Addendum

Project:	M3 Junction 12 Improvements		
Subject:	Model Forecasting and Option Report - Addendum		
Author:	Akash Prakasan, Robert Sheal	Atkins No.:	5163196
Date:	03/12/2018	Icepac No.:	
		Project No.:	
Distribution:	Graham Tuck	Representing:	Eastleigh Borough Council

Revised Option - Proposed Changes

Drawing Title
GENERAL ARRANGEMENT (REVISED OPTION)

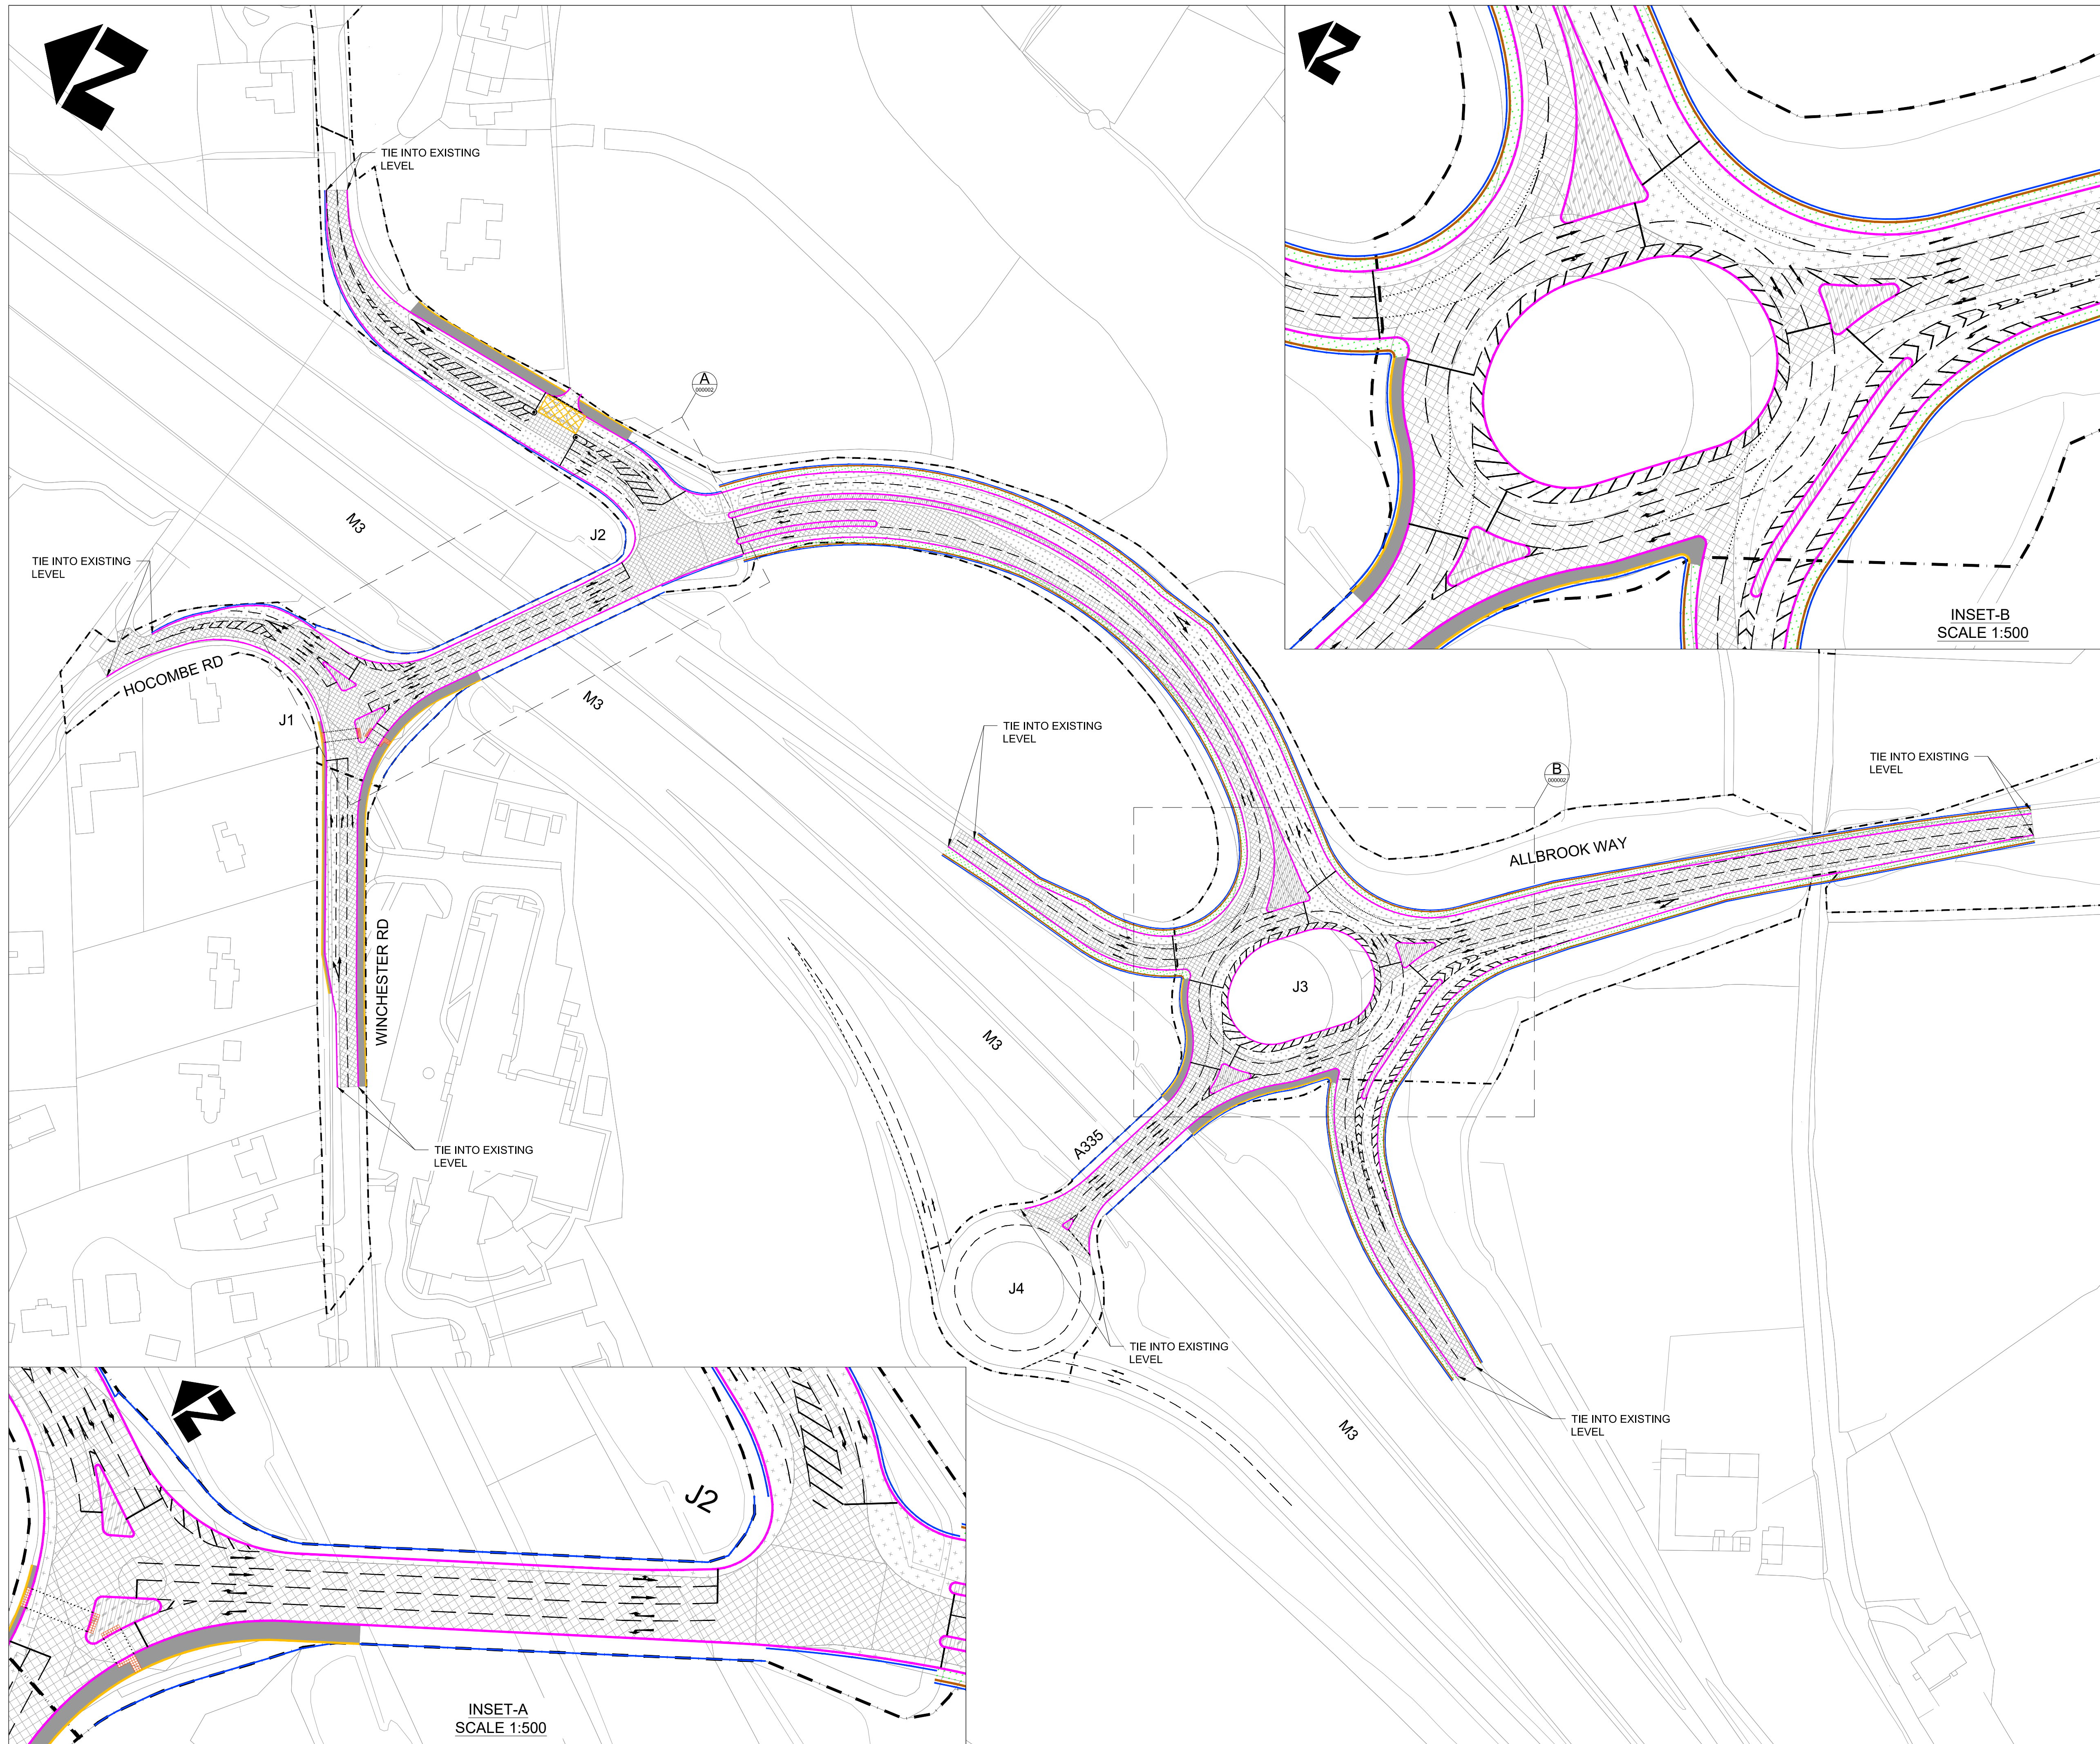
In discussions with Atkins SNC Lavalin design colleagues, the Revised Option includes a number changes as detailed below, and shown in Drawing 5163169-ATK-HML-0000-M2-CH-000002_Option_6, attached in Appendix B.

The junction has been left unchanged with four lanes retained on the motorway overbridge. Testing was undertaken with the aim of reducing the number of lanes to three by converting the two long lanes on the J1 approach to one long lane and one short lane. Design constraints (particularly the bridge structure itself) meant that the proposed right-turn flare was of insufficient length to accommodate the demand in the PM peak and that queues backed up from J1 through J2 to J3.

The number of lanes for the ahead movement from Winchester Road to the motorway overbridge has been reduced from two lanes to one lane. Testing was also undertaken to determine whether the length of the two-lane section southbound on Otterbourne Road on the approach to the signal at the hospital access could be reduced. Queueing on Otterbourne Road is sensitive to capacity for right-turners at J2 however and it was not possible to reduce the length of the two-lane section without long queues forming.

The number of lanes on the M3 Junction 12 motorway overbridge has been reduced to from four lanes to three lanes. This has meant that the western part of the J3 roundabout circulatory has been reduced from four to three lanes and the southern part from three to two lanes. The by-pass proposed from the Winchester Road to Allbrook Way arms has been removed and the flare on the Allbrook Way approach has also been removed, reducing the number of lanes on the approach from three to two.

Initial modelling with LinSig revealed Allbrook Way require a full two lanes southbound as previously proposed.

The westbound entry into the roundabout has been reduced from two to one lane with the reduction of the number of lanes on the bridge from four to three.

- A reduction in the number of lanes proposed on the M3 Junction 12 junction motorway overbridge from four to three;
- A reduction in the number of lanes proposed on the M3 Junction 12 eastern roundabout from four to three on the western part of the circulatory carriageway and from three to two on the southern part;
- Removal of the proposed free flow by-pass from Winchester Road to Allbrook Way;
- Reduction in the number of lanes proposed at the Allbrook Way entry on to the eastern roundabout from three to two, and;
- Reduction in the number of lanes proposed westbound towards the motorway overbridge from two to one on the Winchester Road approach at the Otterbourne Road/Winchester Road junction.

Proposals for the Hocombe Road/Winchester Road junction remain unchanged, with four lanes retained on the adjacent motorway overbridge. Testing was undertaken with the aim of reducing the number of lanes to three by converting the two long lanes on the Hocombe Road/Winchester Road approach to one long lane and one short lane. Design constraints (particularly the bridge structure itself) meant that the proposed flare for right-turning vehicles was of insufficient length to accommodate the demand in the PM peak and that the queues backed up through the Otterbourne Road/Winchester Road junction as far as the M3 Junction 12 eastern roundabout.
